**BEFORE THE HAMILTON CITY COUNCIL**

**IN THE MATTER** of a resource consent application lodged by Foodstuffs North Island Limited ("**Applicant**") to establish a new supermarket and a drive-through fuelling facility ("**Application**") at 980 Te Rapa Road, Pukete, Hamilton ("**Site**")

**STATEMENT OF EVIDENCE OF JOHN PARLANE  
ON BEHALF OF THE BASE TE AWA LIMITED**

**TRANSPORTATION**

Figure 16  
Wairere Drive/Karewa Place intersection - proposed layout

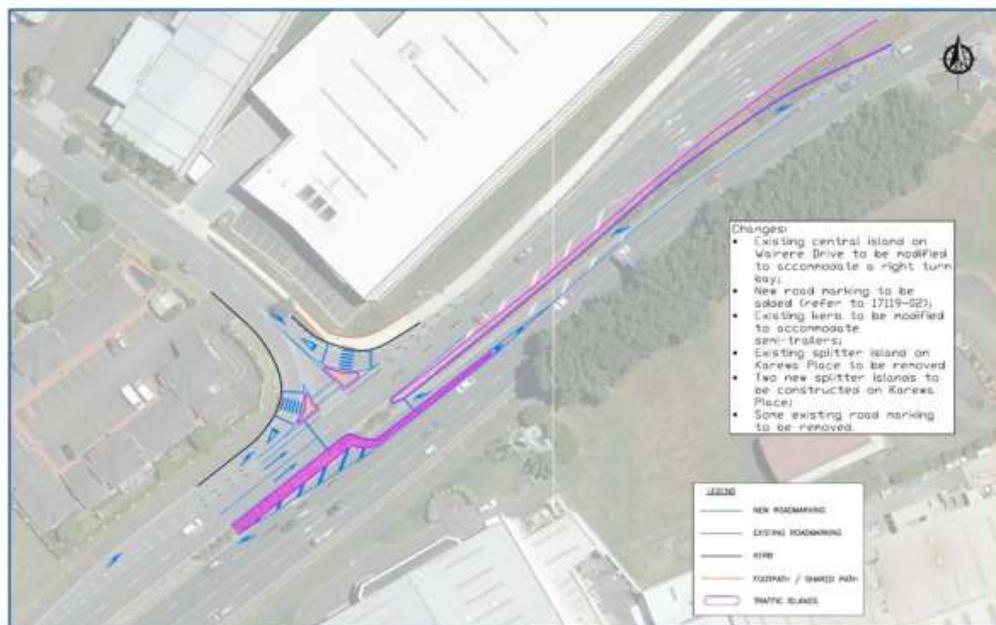
6.4 The intention of this condition is to require a partially signalised intersection where the right turn into Karewa Place is signalised. I suggest that this condition be replaced with a more prescriptive condition that reflects the assumptions that went into the modelling, such as:

- 6.5 In my view this change to the condition is required to ensure the future layout of the intersection matches with the mitigation that has been assessed, as shown in Figure 16 from the ITA below.

Prior to the operation of the supermarket the intersection of Wairere Drive with Karewa Place shall be signalised. The intersection shall provide for:

- Two continuous unsignalised through lanes south west bound on Wairere Drive with a separate signalised right turn into Karewa Place that has a storage length of 100 metres;
- two signalised through lanes on Wairere Drive north east bound with a separate left turn slip lane with a storage length of 50 metres; and
- an unsignalised left turn only lane on Karewa Place.

This signalised intersection is essential to mitigate severe adverse traffic effects that would otherwise be created at

the intersection of Wairere Drive with Te Rapa Road and at the intersection of Te Rapa Road with Eagle Way.
